#### For: Lenoir County Courthouse – HVAC and Basement Renovations

#### ADDENDUM #1

REMOVE THE LAST FOUR (4) SHEETS IN THE BID PACKAGE AND REPLACE WITH THE ATTACHED AS THE LAST FOUR SHEETS.

THESE CONTAIN CLOUDED COMMENTS FROM THE ARCHITECT.

# FIRST FLOOR REFLECTED CEILING PLAN

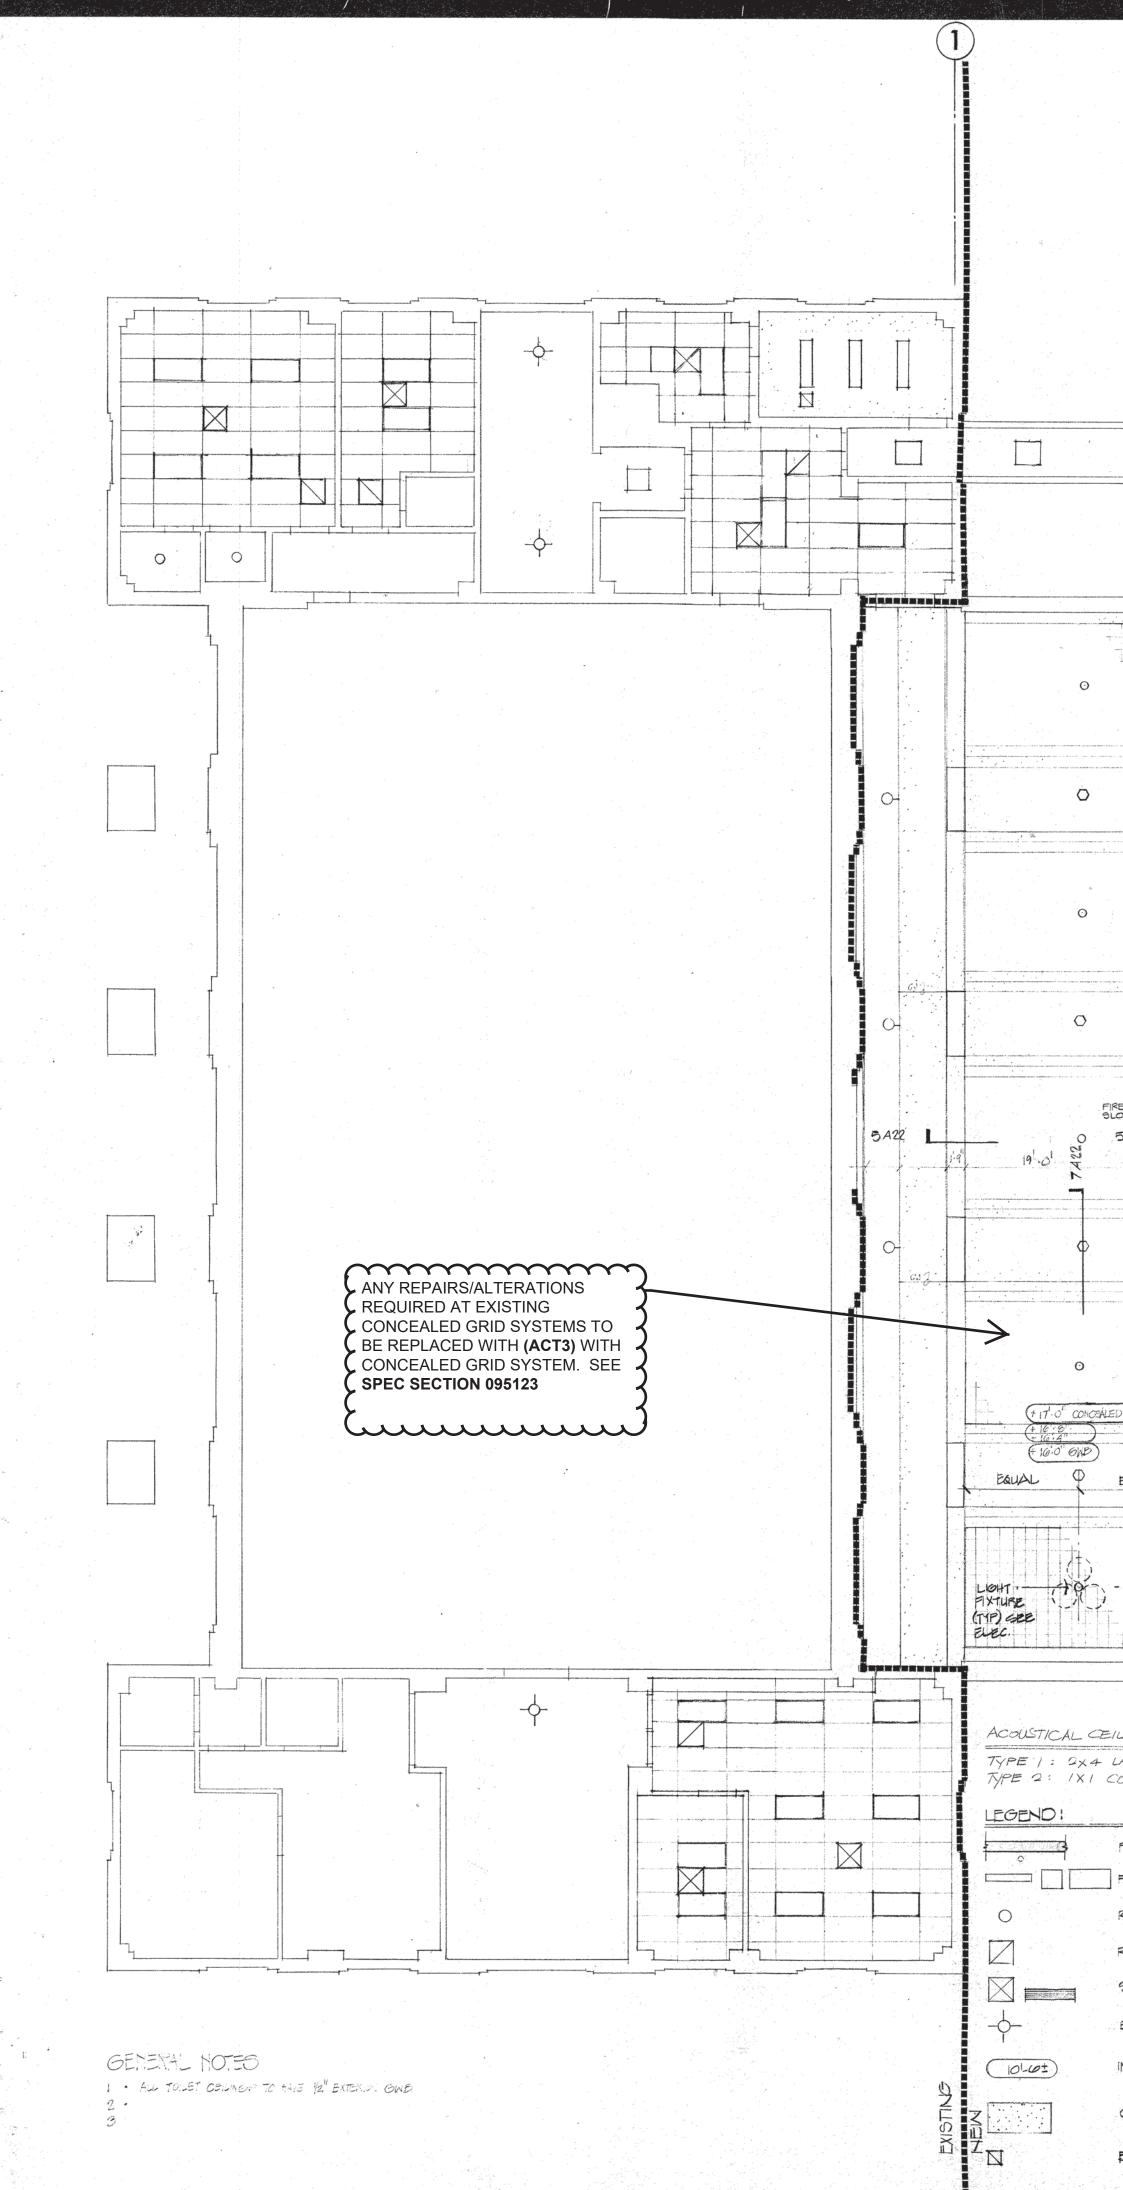
$\overbrace{}$ IN CORRIDOR, EXISTING

SYSTEM TO BE REMOVED AND REPLACED FOR

CEILING. EXISTING GWB

AND WOOD TRIMS TO REMAIN. REPLACE WITH (ACT3) CONCEALED GRID

CONCEALED GRID

ACCESS TO ABOVE

SYSTEM. SEE SPEC

SECTION 095123

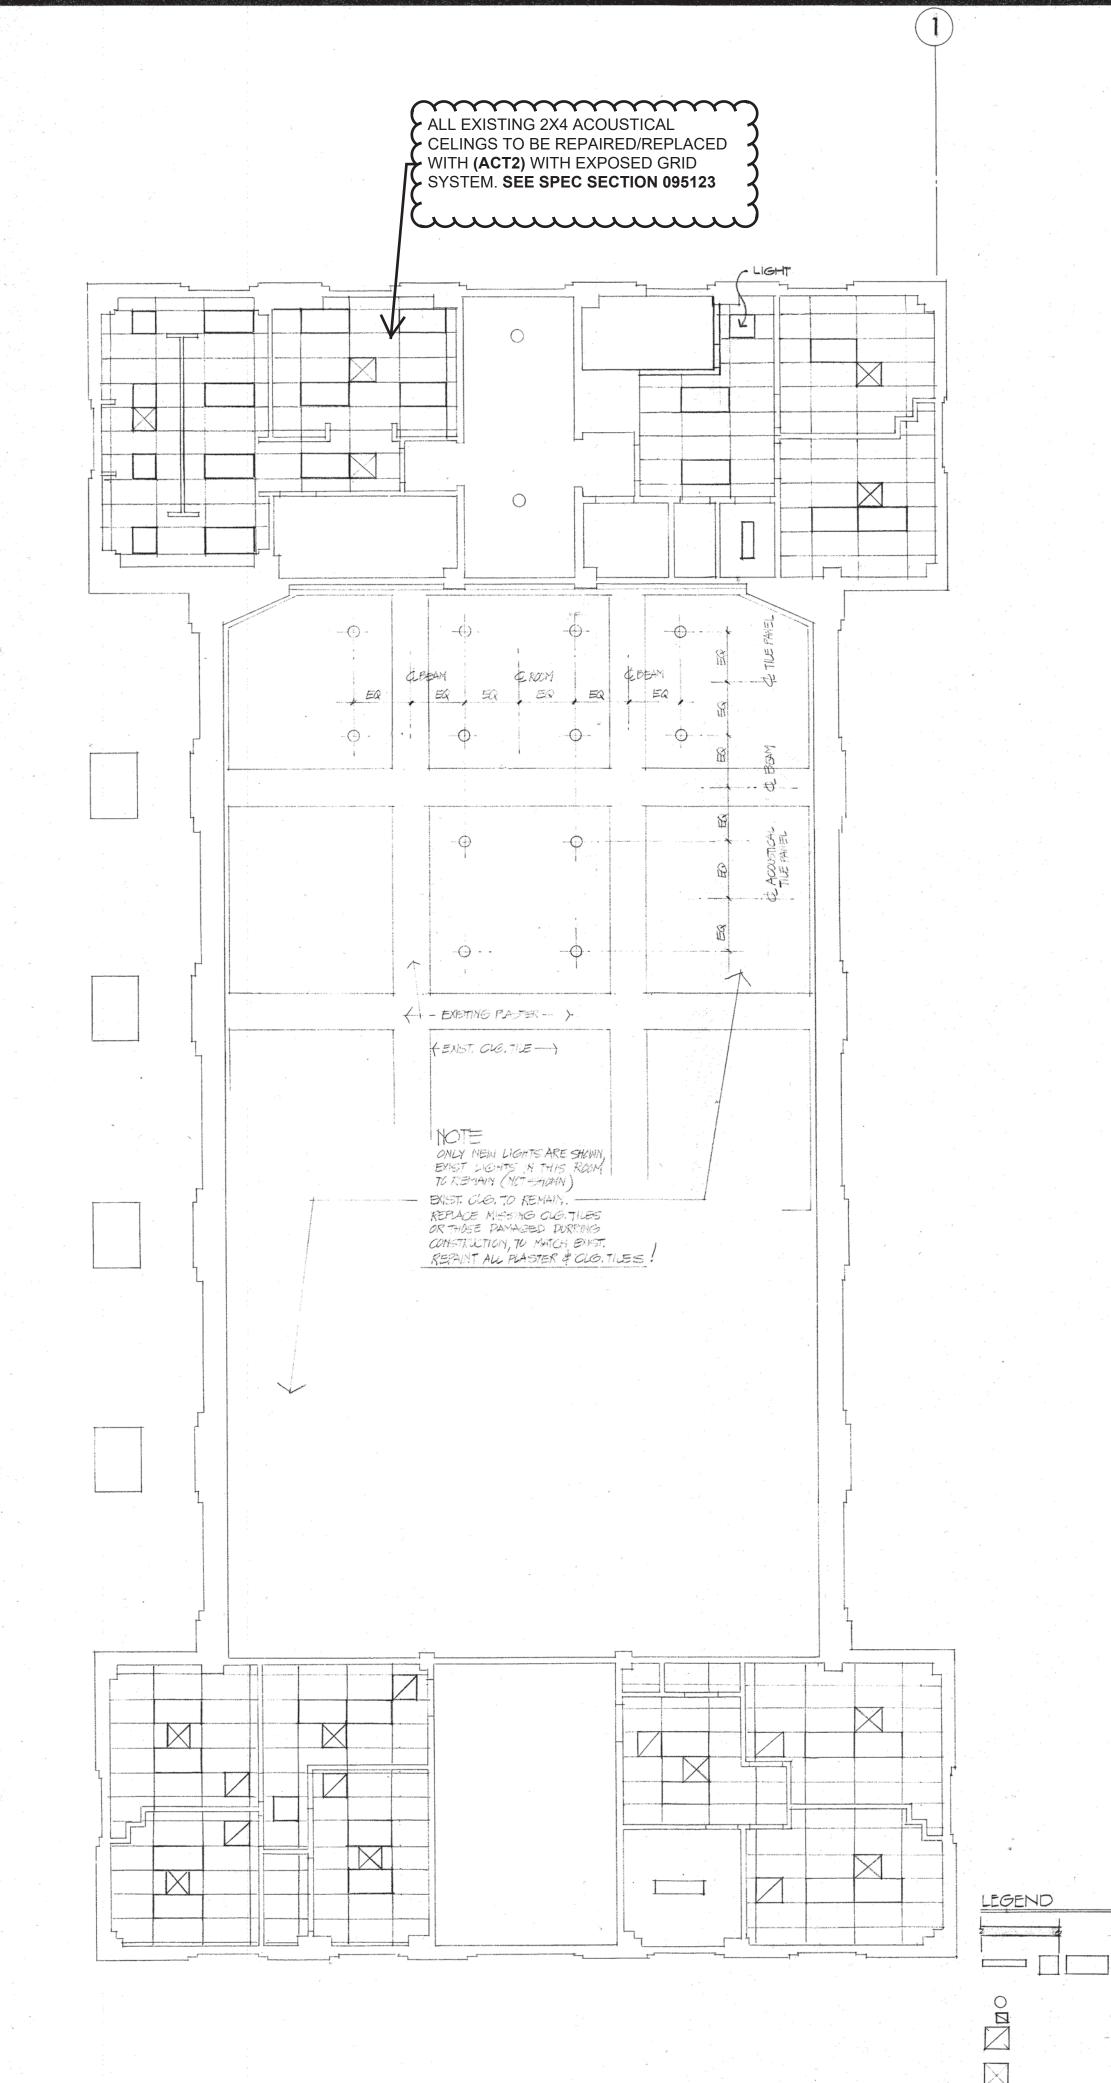
$(\mathbf{A})$ B D AT CORRIDOR EXISTING CONCEALED GRID SYSTEM TO BE REMOVED AND REPLACED FOR ABOVE CEILING ACCESS. EXISTING GWB AND WOOD TRIMS TO REMAIN. REPLACE WITH (ACT3) WITH CONCEALED GRID SYSTEM. SEE SPEC SECTION 095123 (uuuuuu) G ALL EXISTING 2x4 ACOUSTICAL CEILINGS TO BE REPAIRED/ REPLACED WITH (ACT2) WITH EXPOSED GRID SYSTEM, UNLESS NOTED OTHERWISE. SEE SPEC SECTION 095123 (mmmm) J
